ADDENDUM NO. [1]

Date: March 26, 2018

**RE: WITC – SUPERIOR CAMPUS
PLUMBING AND HVAC MAINTENANCE
600 N 21ST STREET
SUPERIOR, WI 54880
HSR PROJECT NO. 17063-2 & 7**

**FROM: HSR Associates, Inc
100 Milwaukee Street
La Crosse, WI 54603
(608) 784-1830**

4 MECHANICAL SECTION - BB (REMODEL)
1/4" = 1'-0"

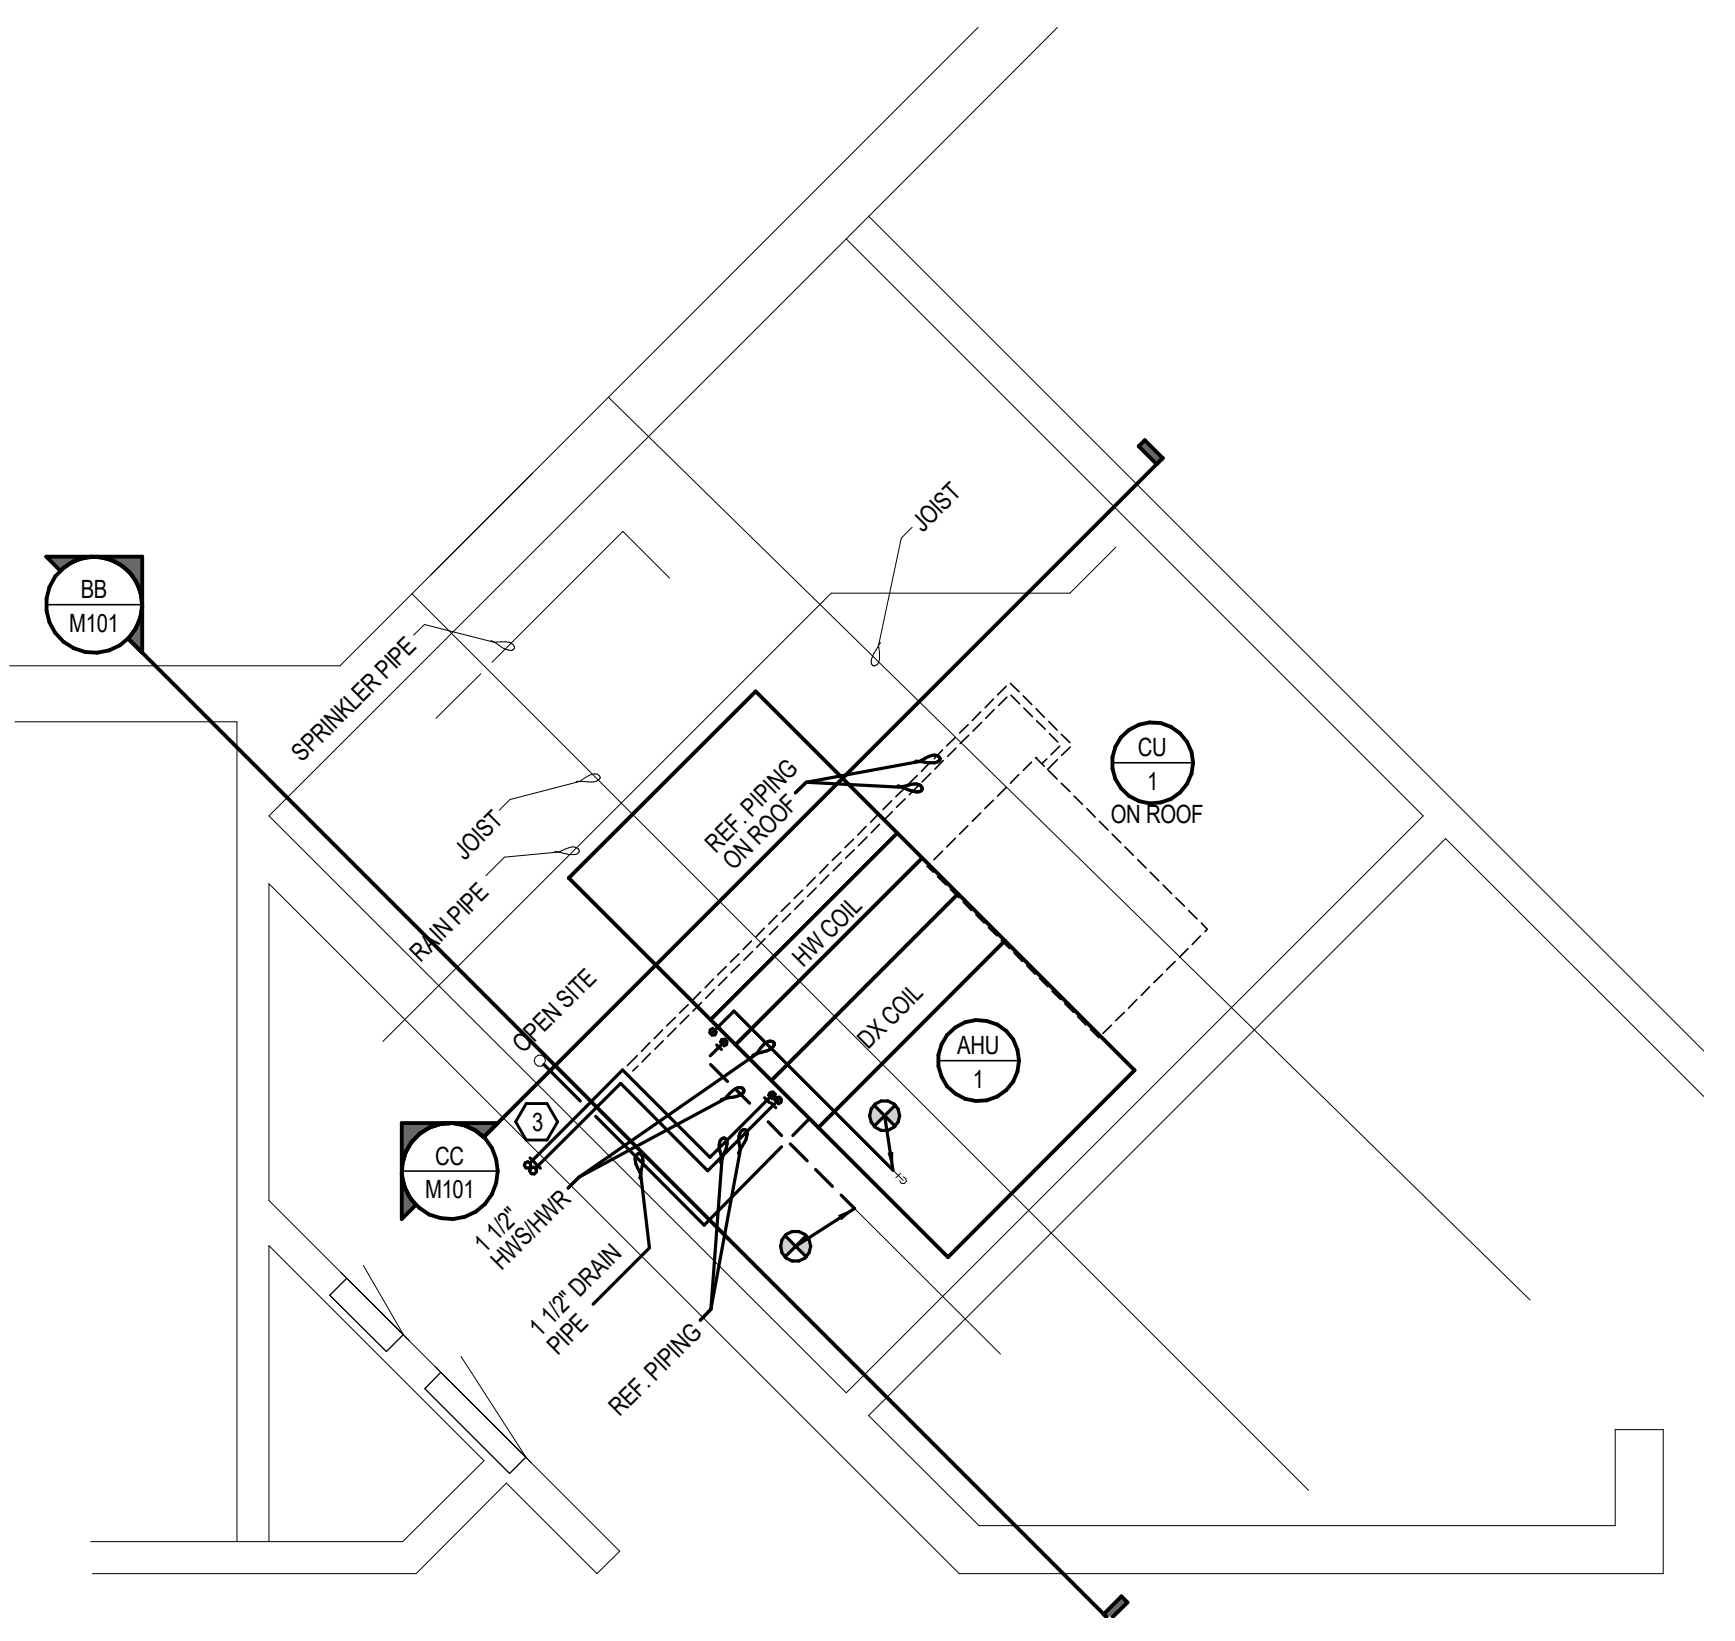
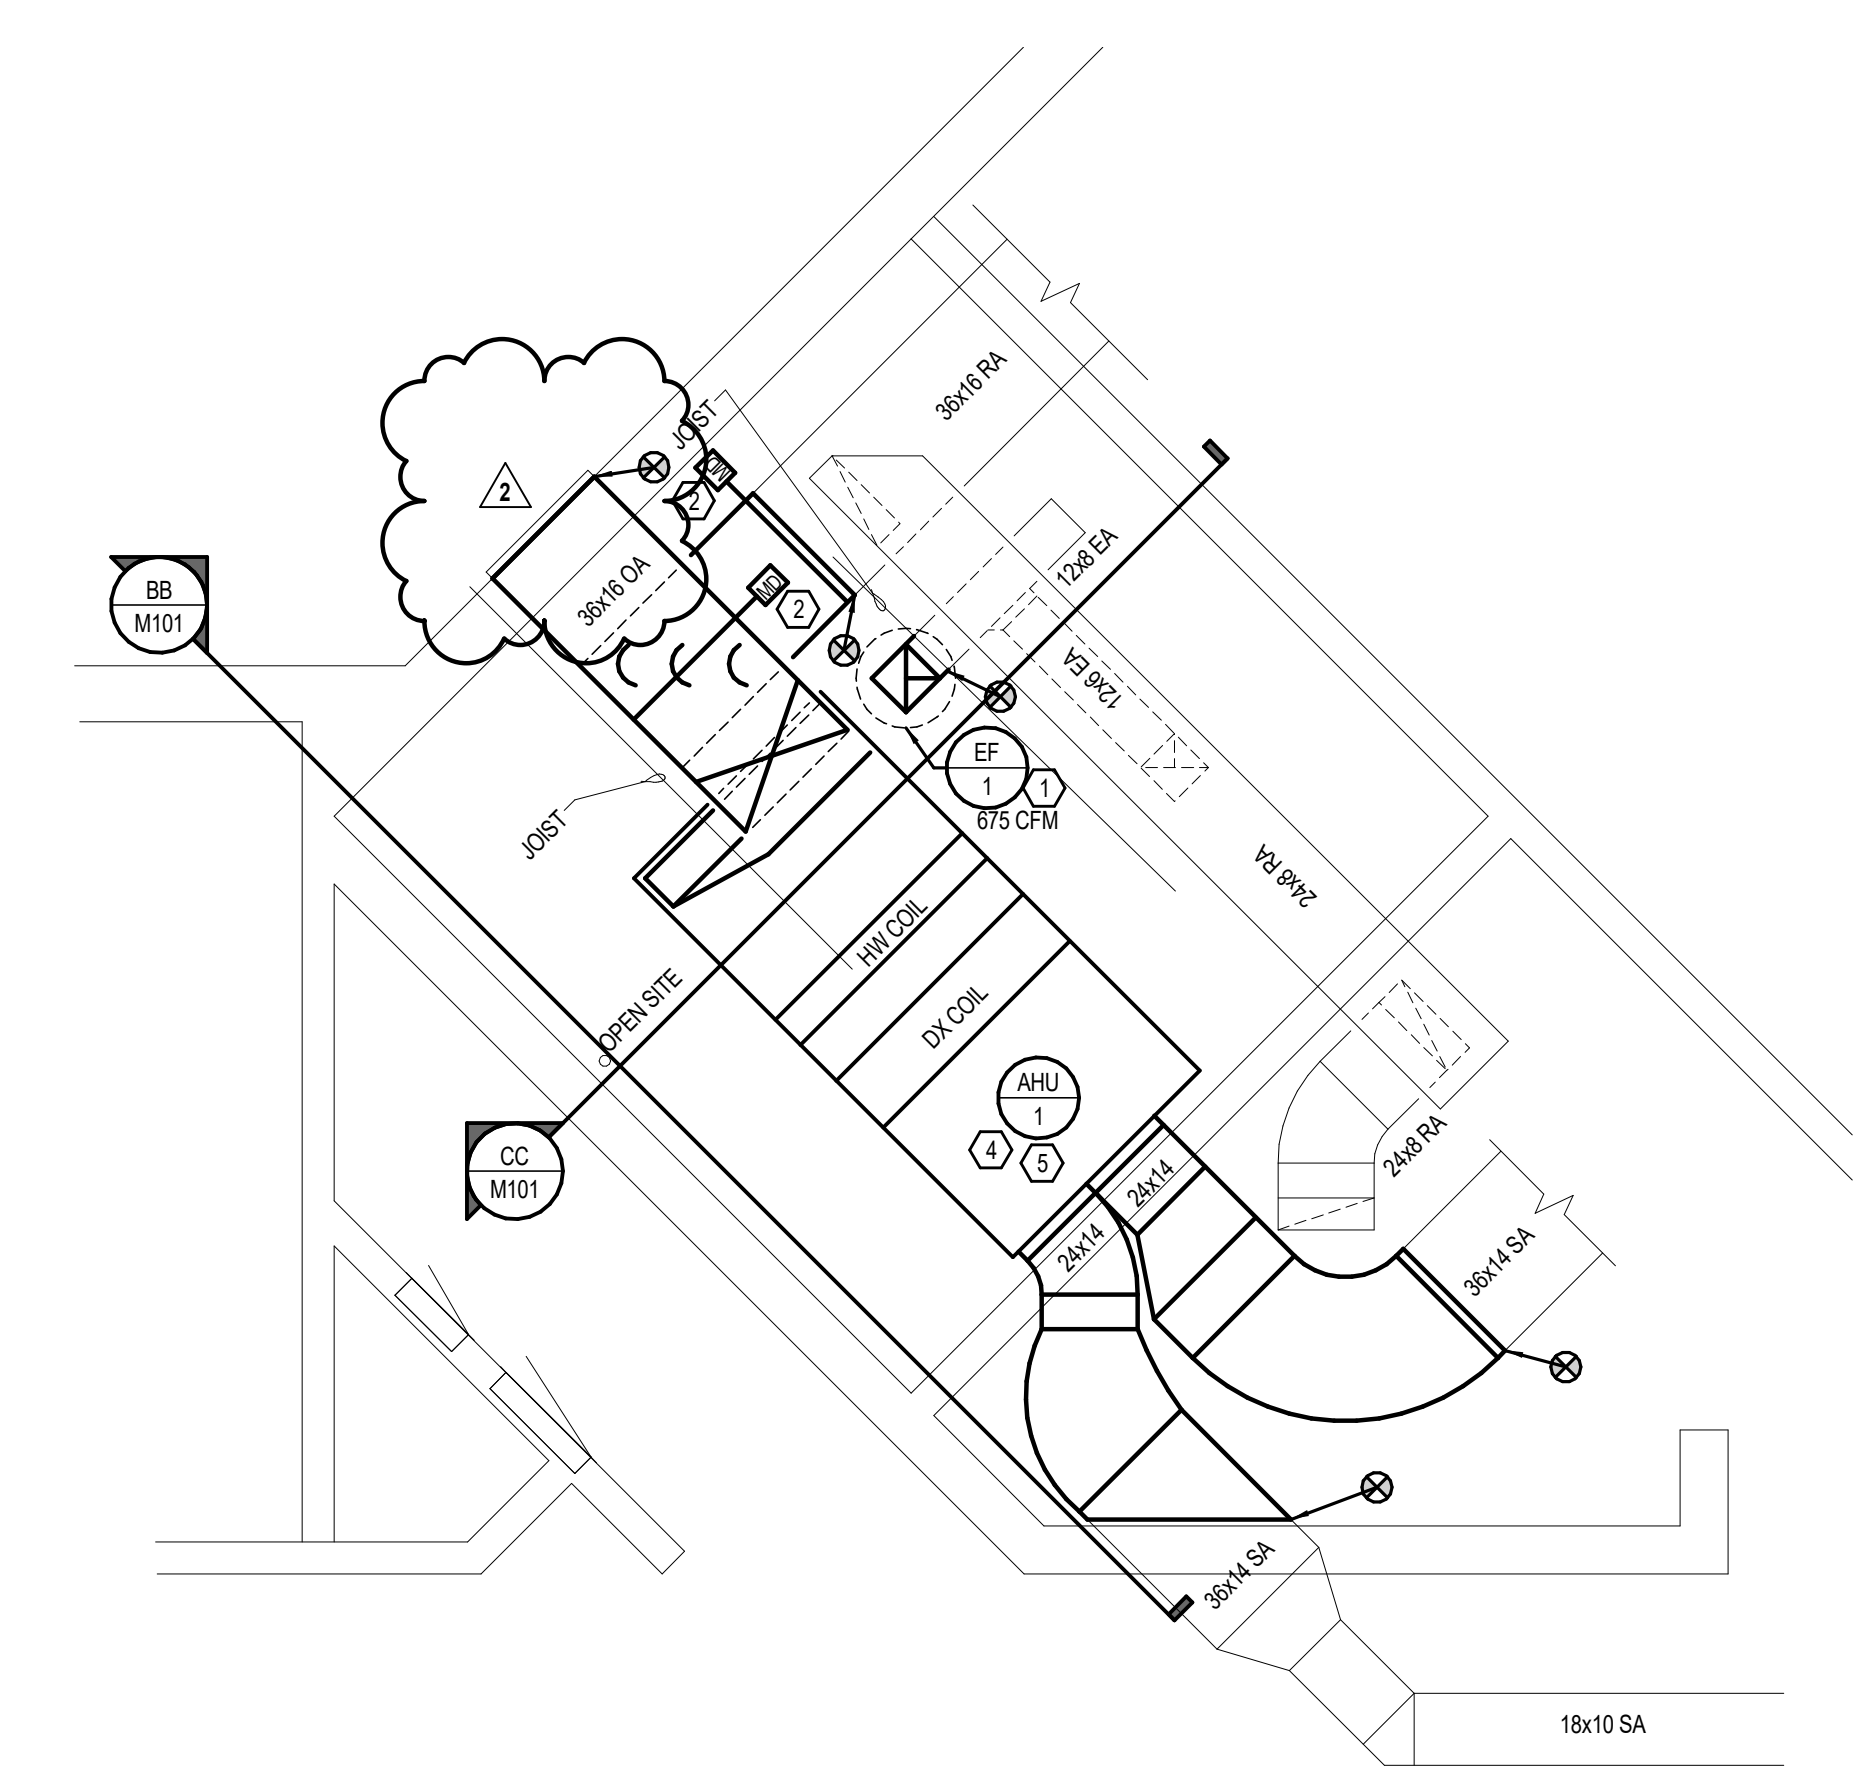
- a. Keynote 2: Delete “reuse existing water cooler”. Water coolers will be new and installed in a high/low fashion.
17. Sheet M101R MECHANICAL DUCTWORK AND PIPING PLANS – AHU 30 x 42 attached hereto

- a. Revisions clouded on Drawing.
18. Sheet M501 MECHANICAL DETAILS AND SCHEDULE
 - a. Remove the Louver Schedule in its entirety.
19. Sheet E001 ELECTRICAL NOTES, LEGENDS & ABBREVIATIONS

E103

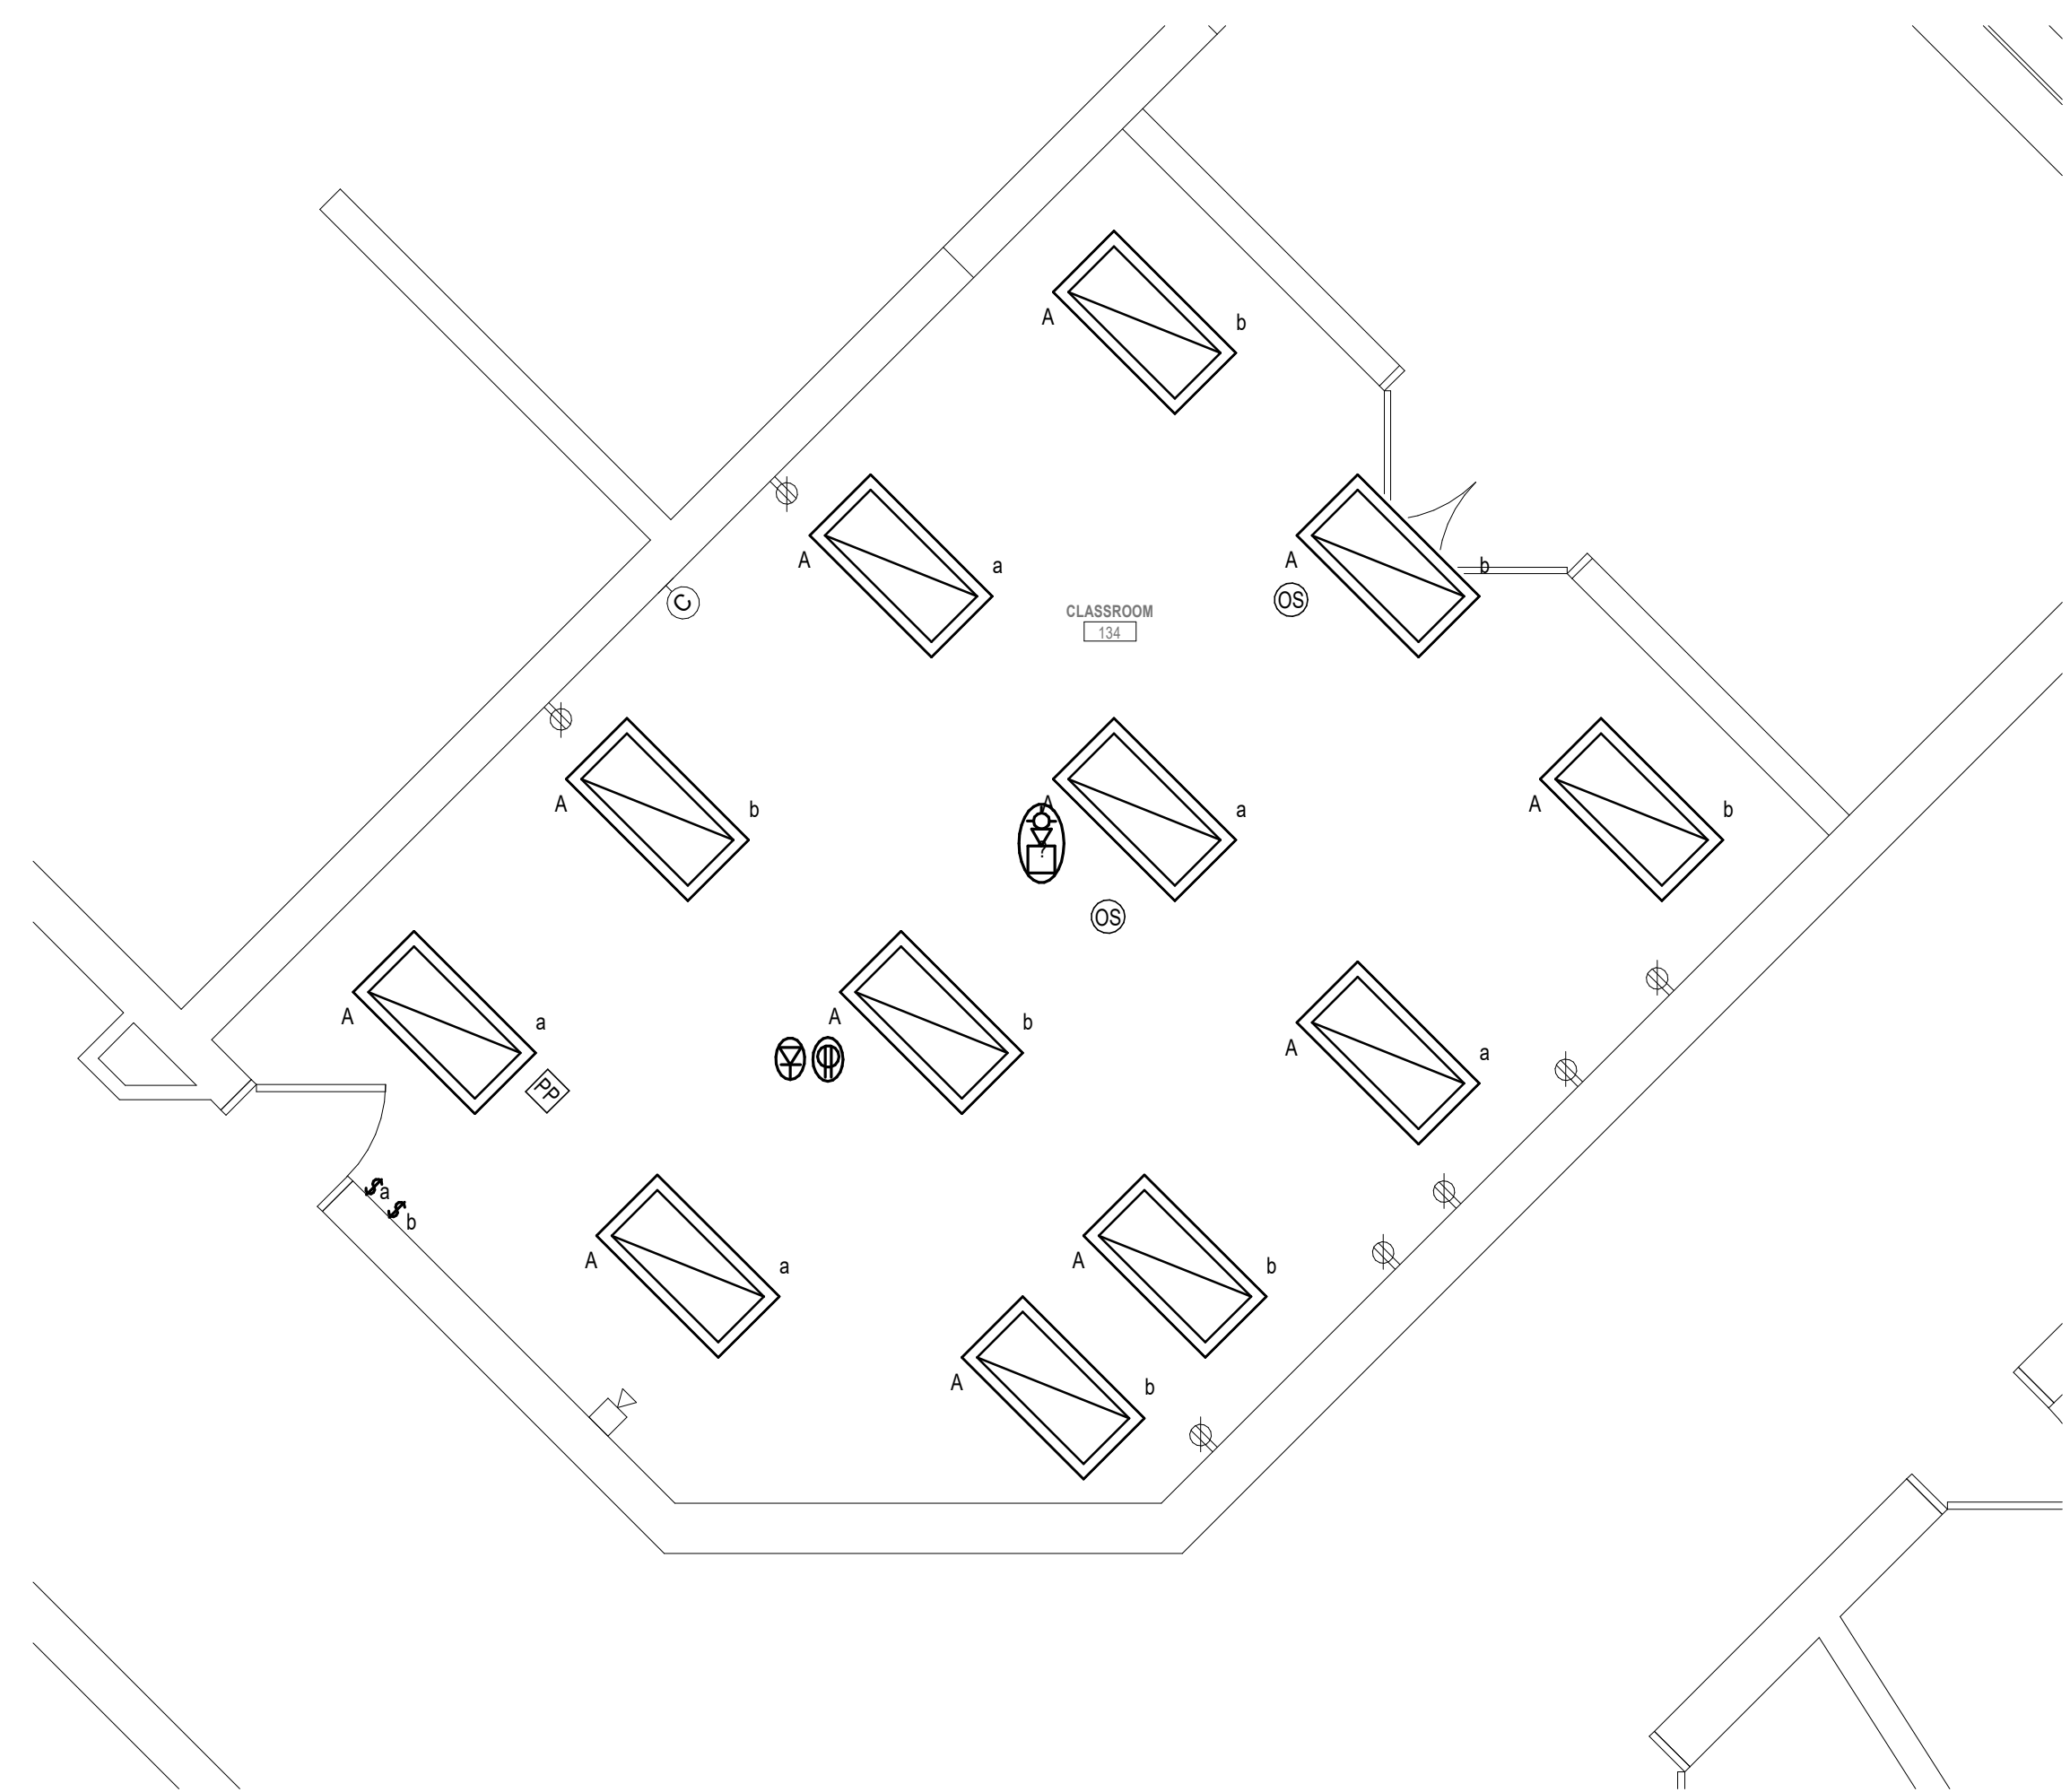
21. Sheet E103 ELECTRICAL PLAN – AREA “C” 30 x 42 attached hereto

- a. Drawing added as part of Contract Documents.
